Addendum # 5

Bid Opportunity: 25-7748-RFT - St. Andrew's Public School 3rd Floor Classroom Refinishing Closing Date: Wednesday, May 21, 2025 2:00 PM

Addendum #4

Addendum #:	E-1
--------------------	-----

SHEET NO:
E-302

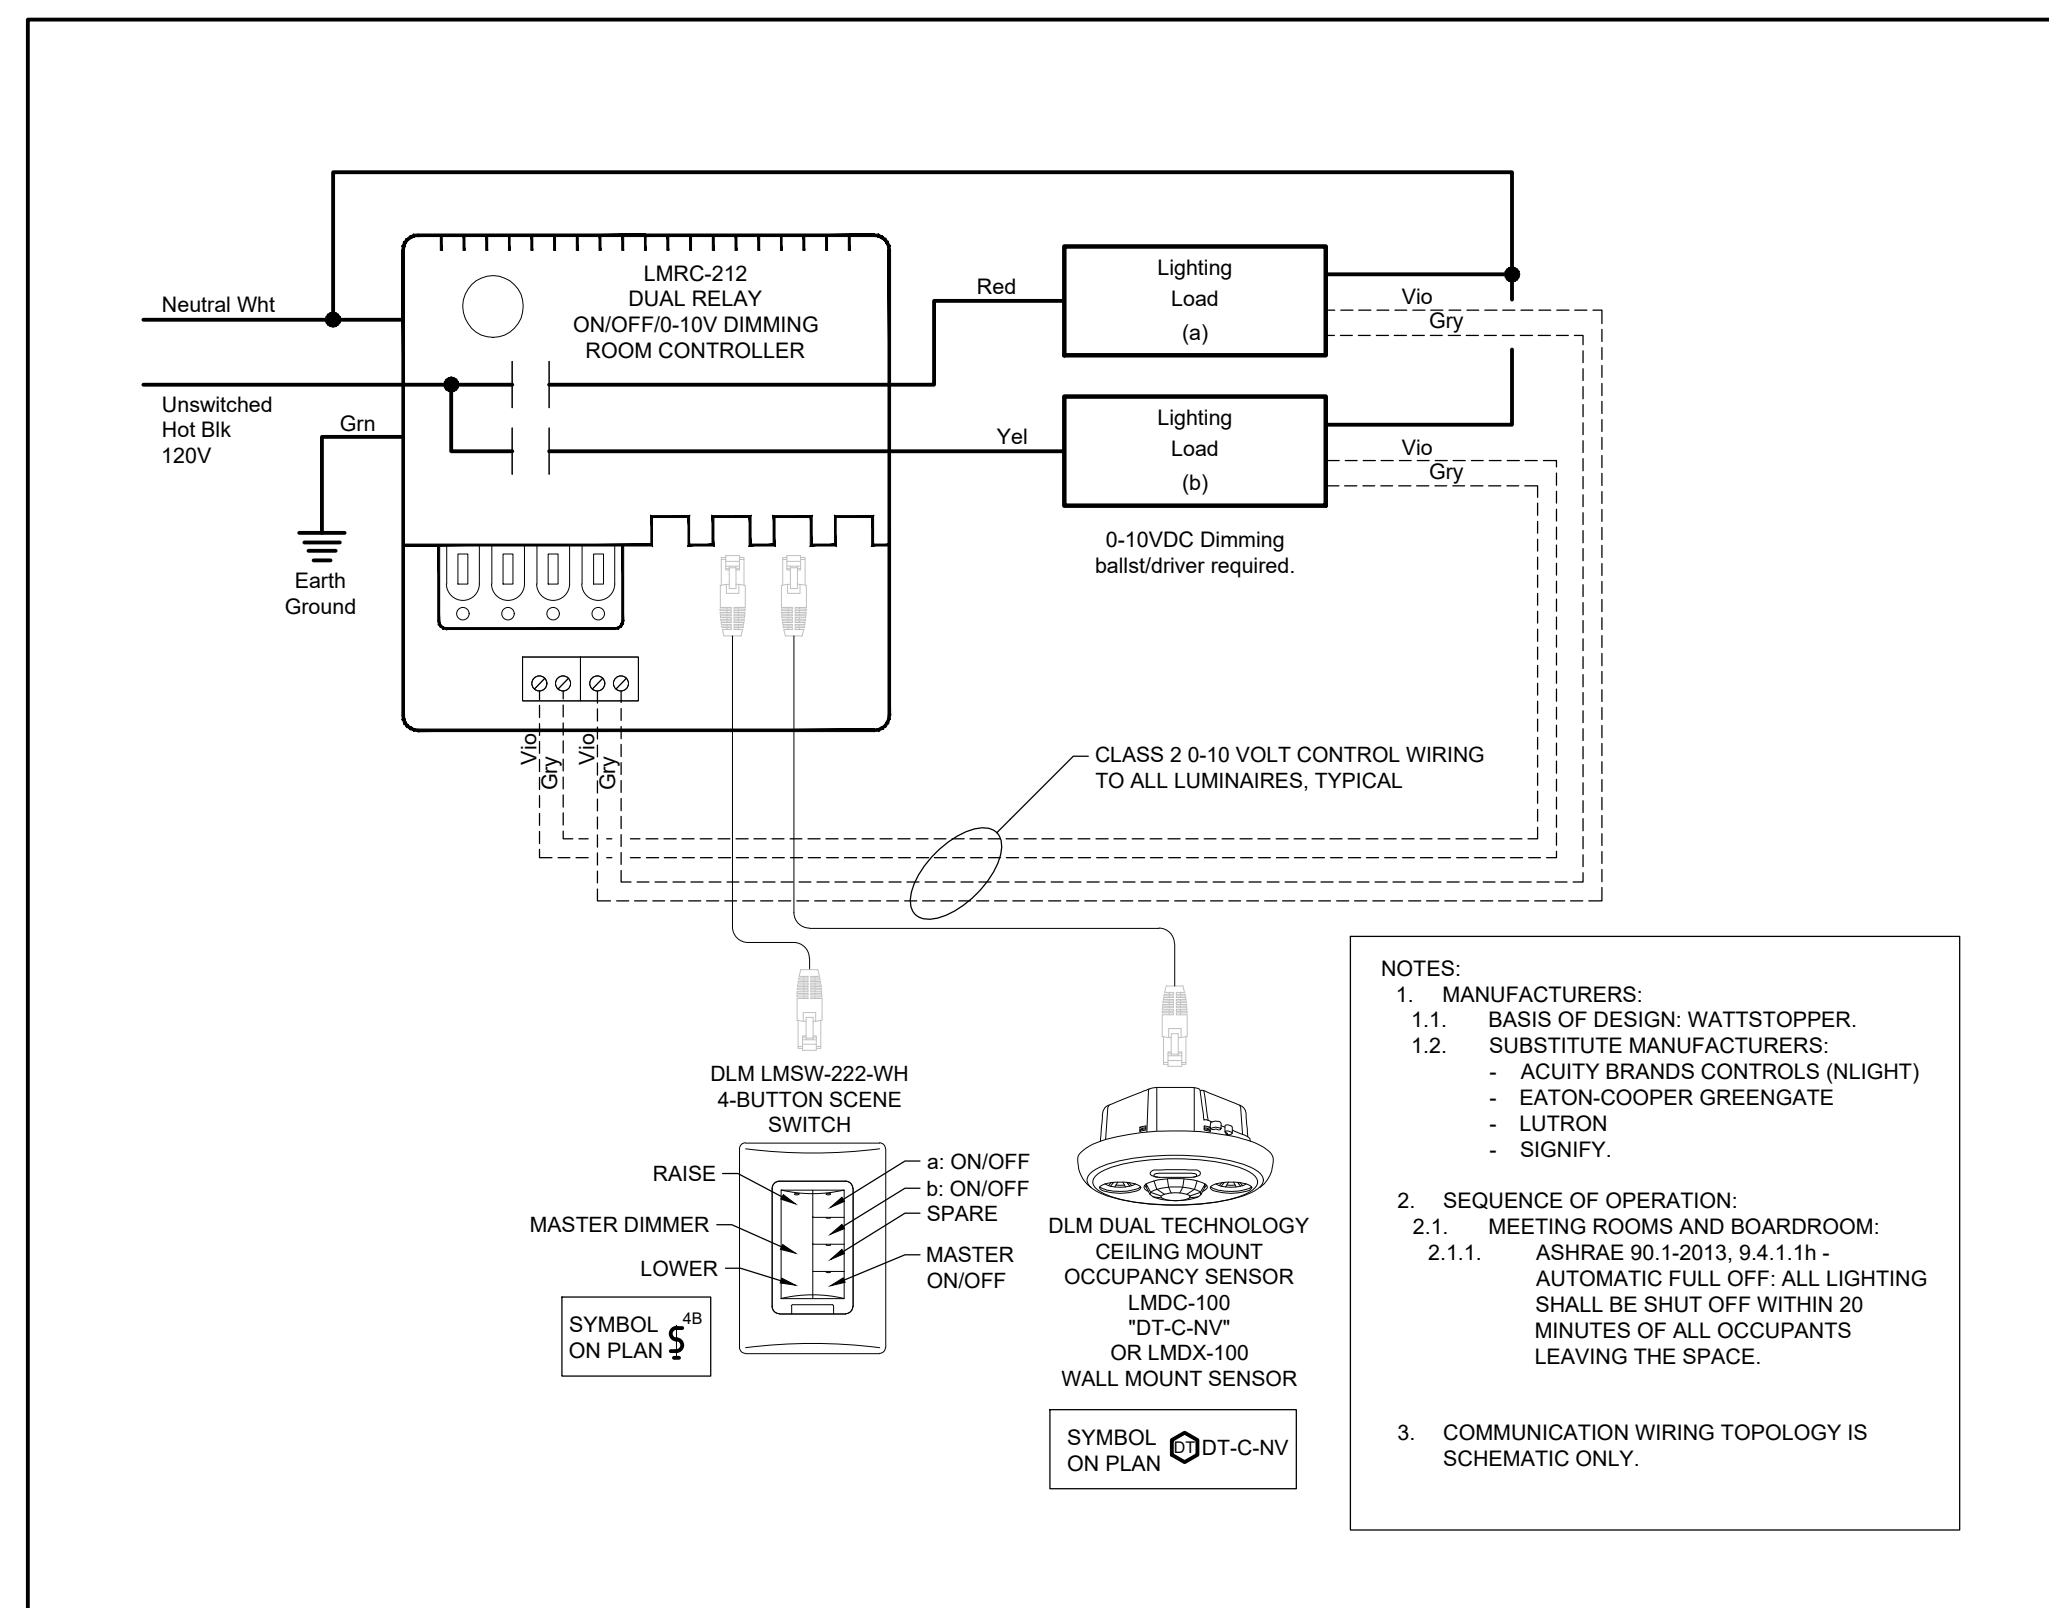
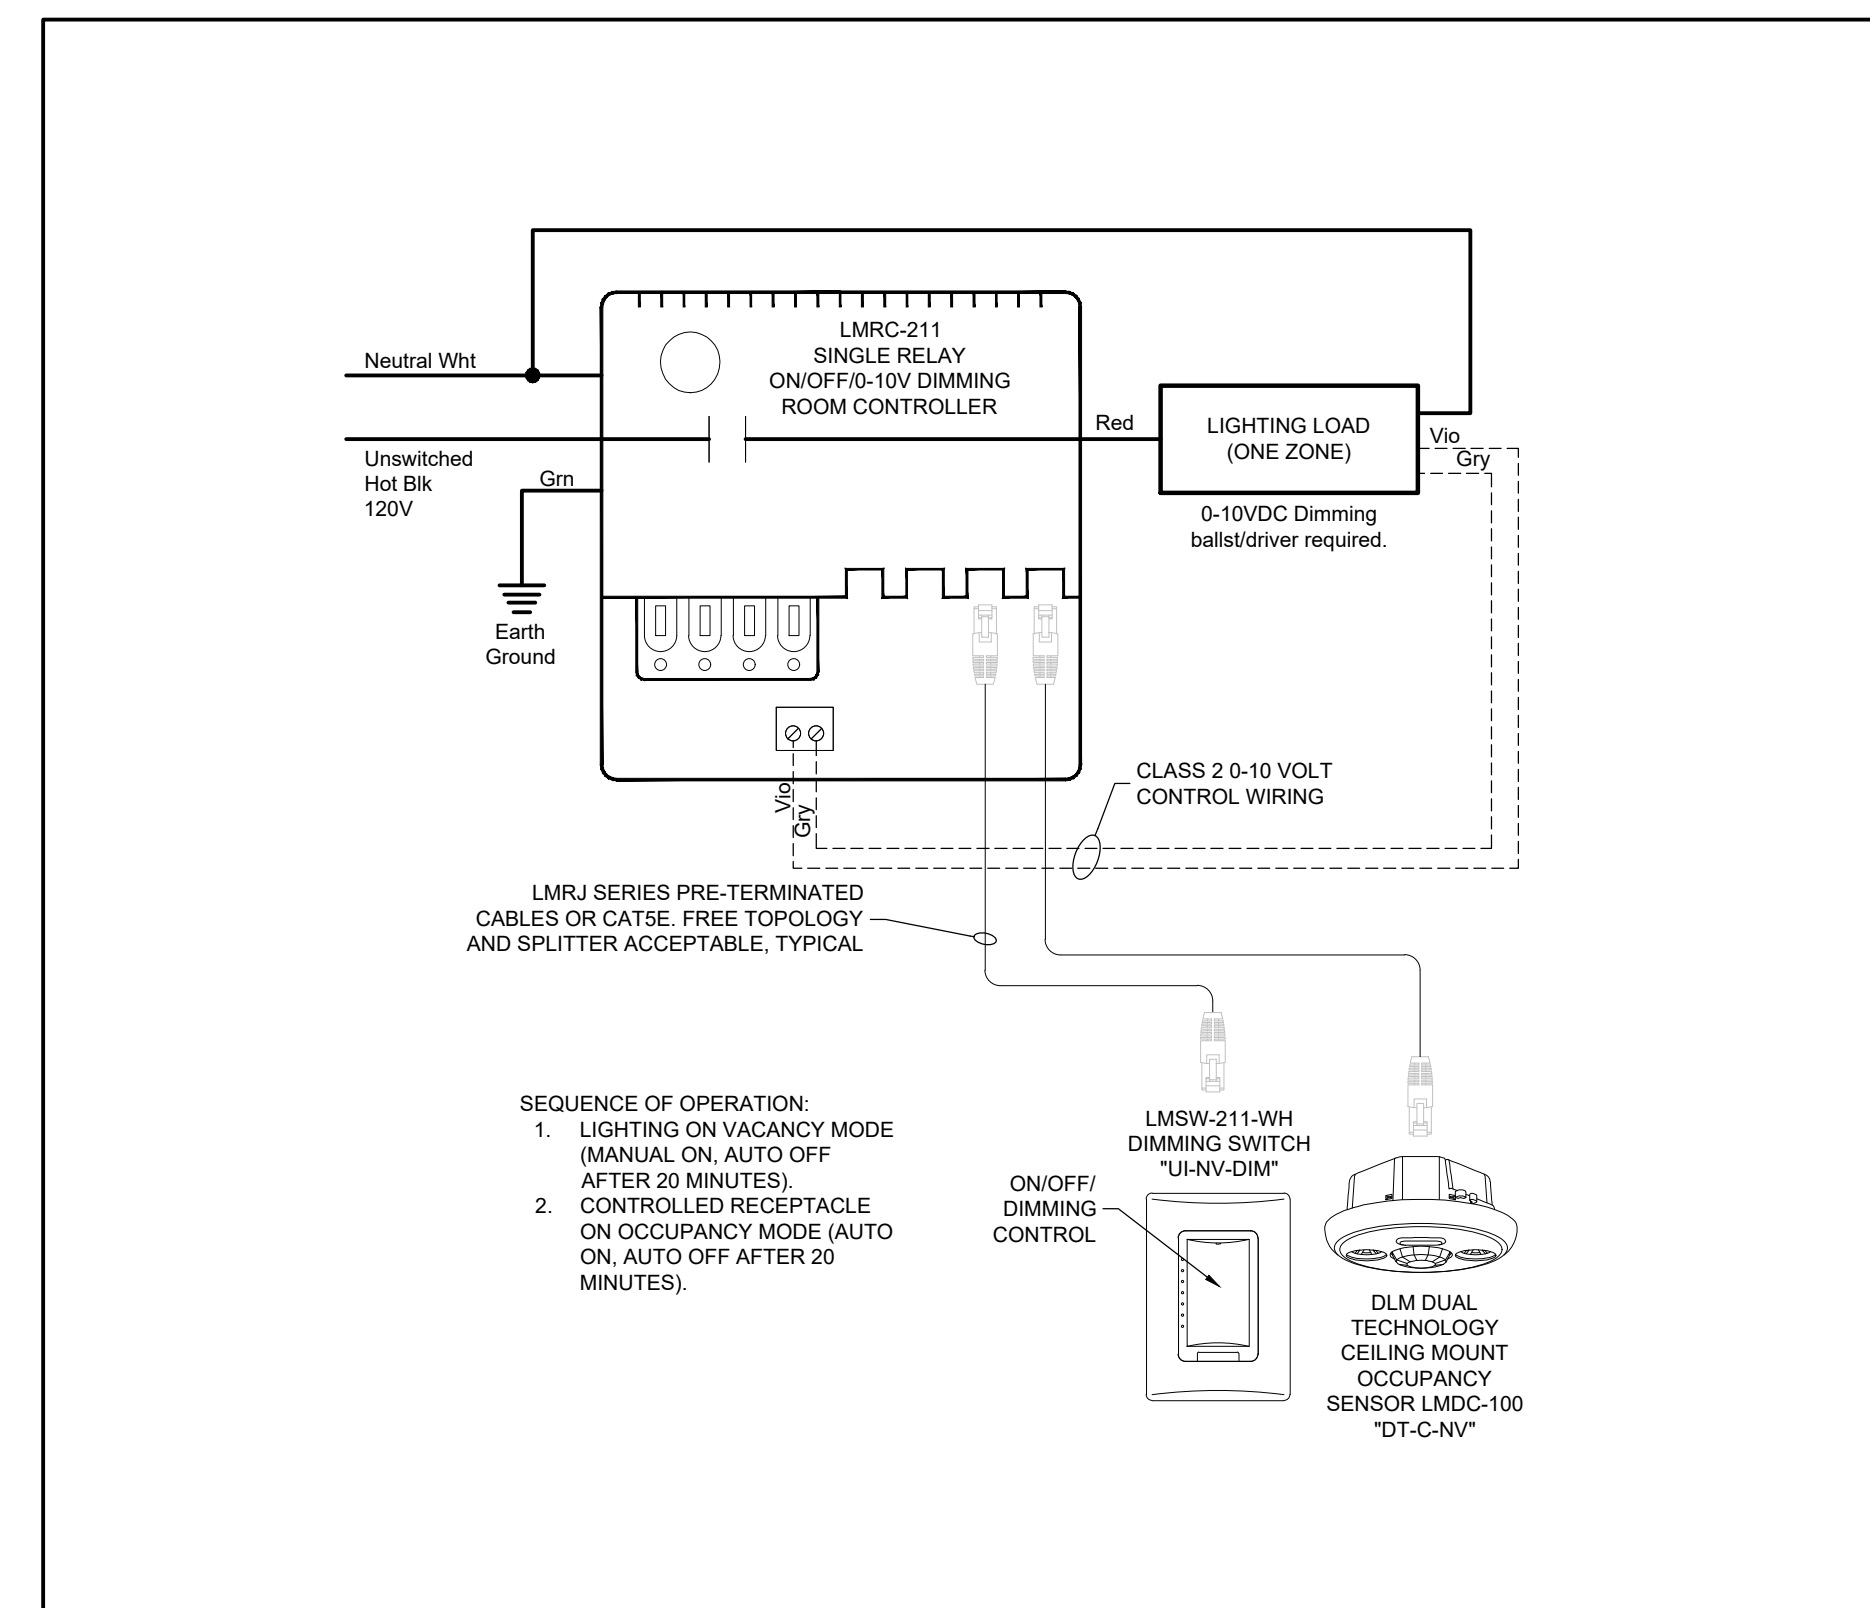
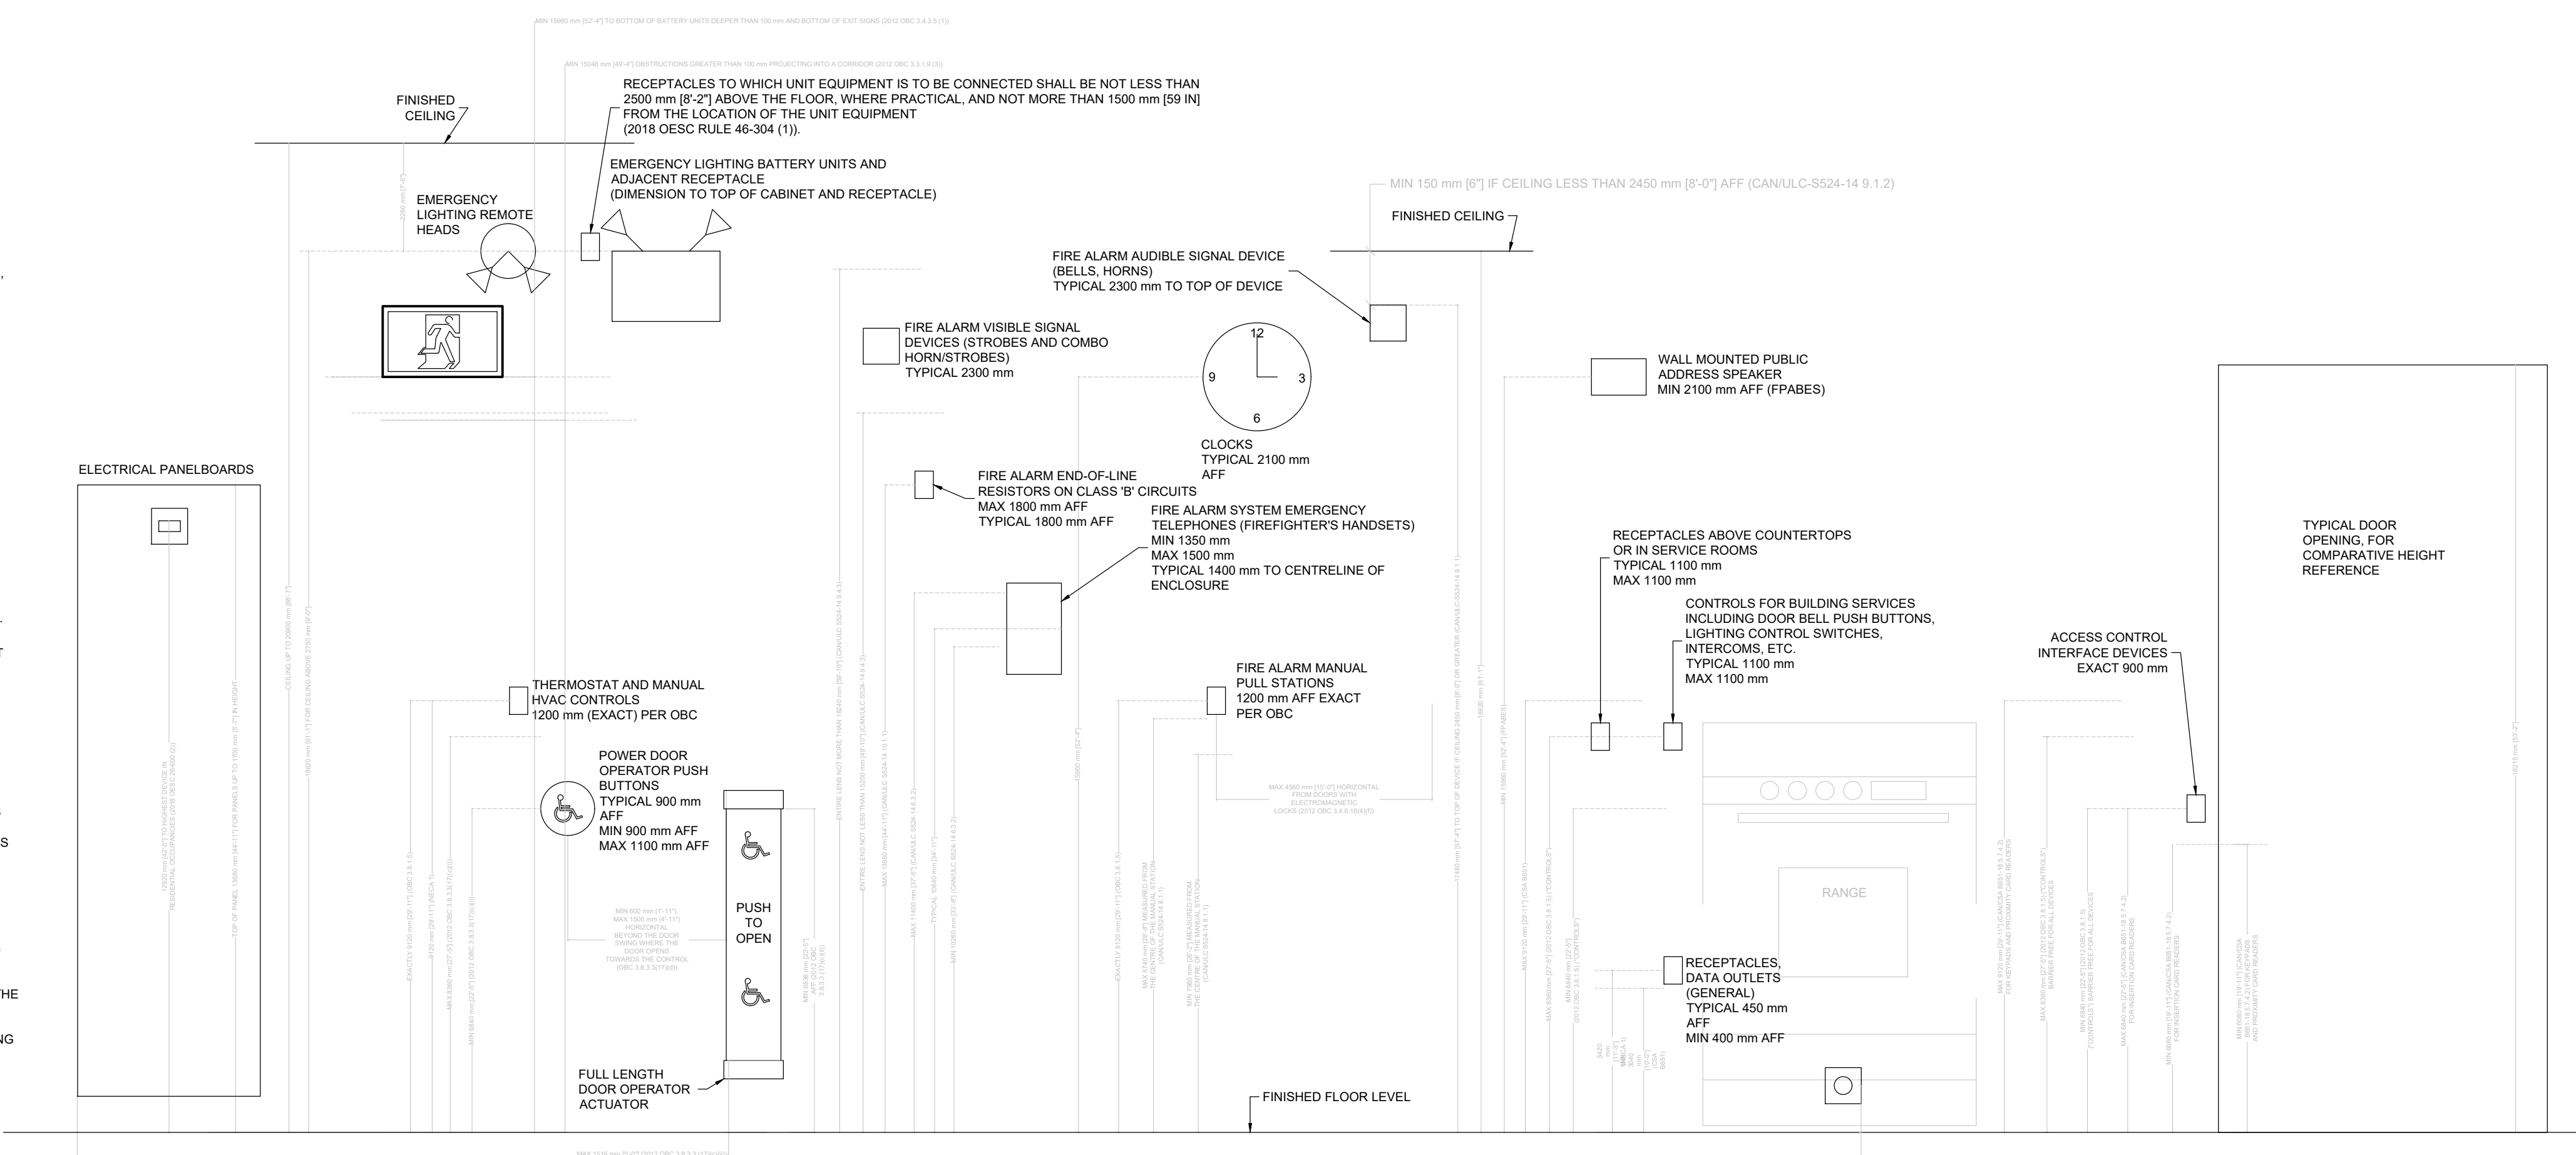
5. Drawing E-302 – Electrical Detail Sheet No. 2 (Issued herewith):

- a. Added lighting control details to this drawing.
